**IEEE P802.11****Wireless Access Method and Physical Layer Specification**

**Changes to all clauses except Annex C Between D5.3 and D6.1**

This document lists the changes made to the draft standard 5.3, except the annex c, in the resolution of the LMSC recirculation ballot. For detailed information refer to Draft 5.4 for change bars and to doc. 97/43 for the annex c changes. The annex c does not have a version with change bars because the tools do not provide such feature.

Figure 1, PLCP Frame Format

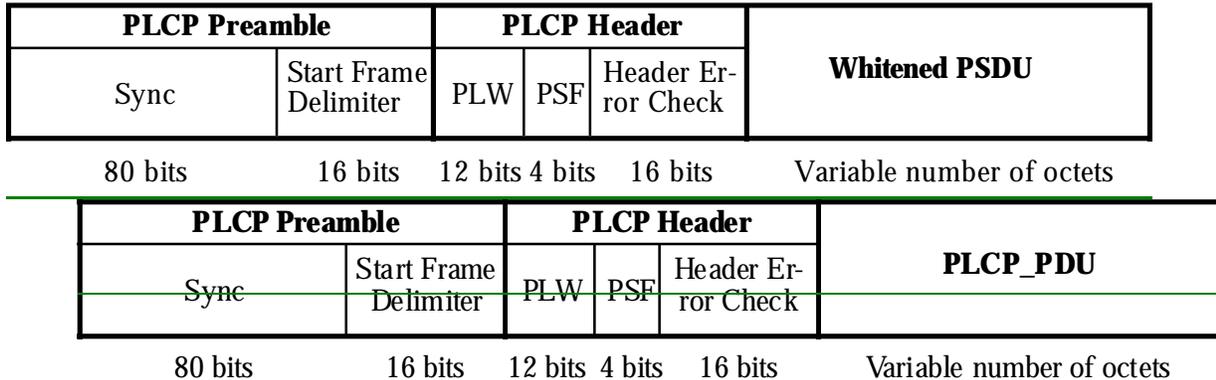
Clause 14.3.2 and Figure 70 changed into:

The ~~PPDU~~~~PLCP~~ Frame Format provides for the asynchronous transfer of MAC sublayer MPDUs from any transmitting station to all receiving stations within the wireless LAN's BSS. The ~~PPDU~~~~PLCP frame format~~ illustrated in Figure 1 consists of three parts: a PLCP Preamble, a PLCP Header, and a ~~PSDU~~~~PLCPDU~~. The PLCP Preamble provides a period of time for several receiver functions. These functions include antenna diversity, clock and data recovery, and field delineation of the PLCP Header and the ~~PSDU~~~~PLCPDU~~. The PLCP Header is used to specify the length of the

~~whitened PSDUM~~MPDU field and support any PLCP management information. The ~~PPDU~~PLCPPDU contains the ~~PLCP Preamble, the PLCP Header, and the PSDUM~~MPDU data modified by the ~~PLCP~~PDU data whitener.
